UNITED STATES PATENT AND TRADEMARK OFFICE

APPLICATION NO.	FILING DATE	FIRST NAMED INVENTOR	ATTORNEY DOCKET NO.	CONFIRMATION NO.
10/658,017	09/08/2003	Joseph Cowan	03-0599 81582	4056

Office Action Summary

DETAILED ACTION

FIG. 5A

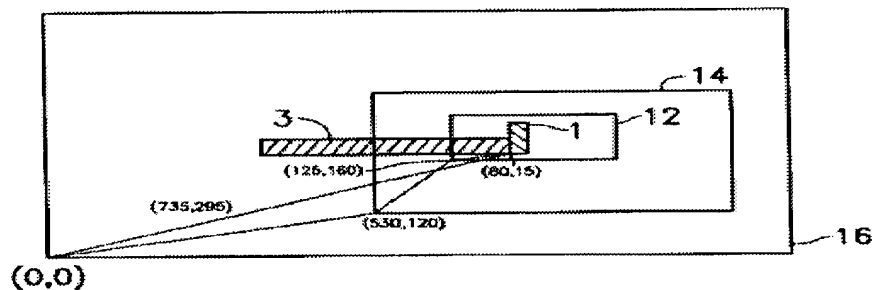
Examiner respectfully asserts that the vertex is a point at which the sides of an angle intersect, and therefore, examiner respectfully asserts that the coordinates such as the vertex (80,15) taught and seen above, by Yang, are vertices.

FIG. 5B

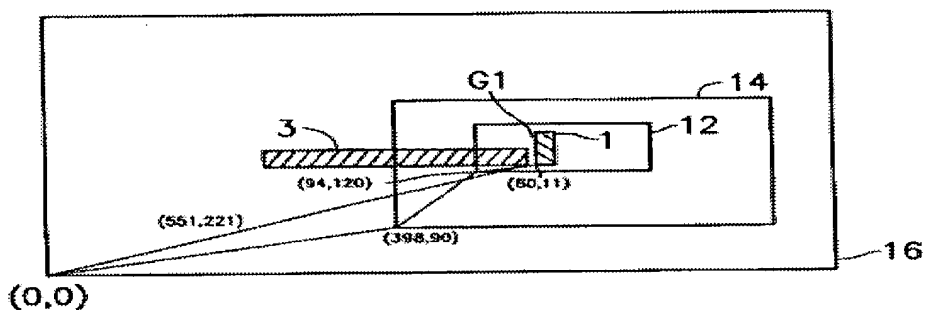
Figure 5B shows the vertices downsized 75%. Clearly, these coordinates are rounded, because $.75 \times 125$ is 93.75, and the figure shows 94. Yang clearly teaches how these coordinates

are rounded in column 3, lines 33-37. Clearly, this goes for all the coordinates (see the difference between figures 5A and 5B).

FIG. 5I

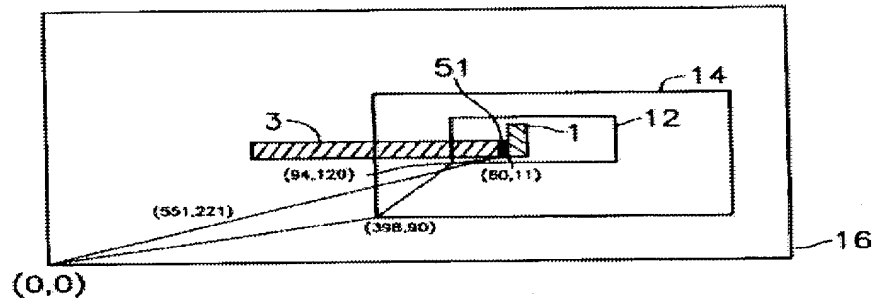
Yang clearly teaches calculating coordinates (551,221) between vertices (94,120) and (60,11), said coordinates (551,221) clearly having been rounded off after downsizing 75% (Col. 5, line 33- Col. 6, line 10).

Although Yang does not say that the rounded coordinates have been calculated having a selected resolution, Yang clearly shows and teaches that all the coordinates are rounded off to the 1's place, and therefore, Yang has clearly chosen a coordinate resolution of 1 for all the coordinates. The examiner believes that there is a difference between selecting a coordinate resolution from a plurality of different coordinate resolutions, which the claims do not require, and simply selecting one coordinate resolution. For example, *although not relied upon in the rejection*, U.S. Pat. No. 5,568,563 to Tanaka clearly teaches selecting a coordinate resolution from a plurality of different coordinate resolutions in column 8, lines 27-44. Tanaka clearly teaches a coordinate resolution of "1" and a coordinate resolution of "0.5". The examiner believes that this reference clearly shows the distinction between selecting a coordinate
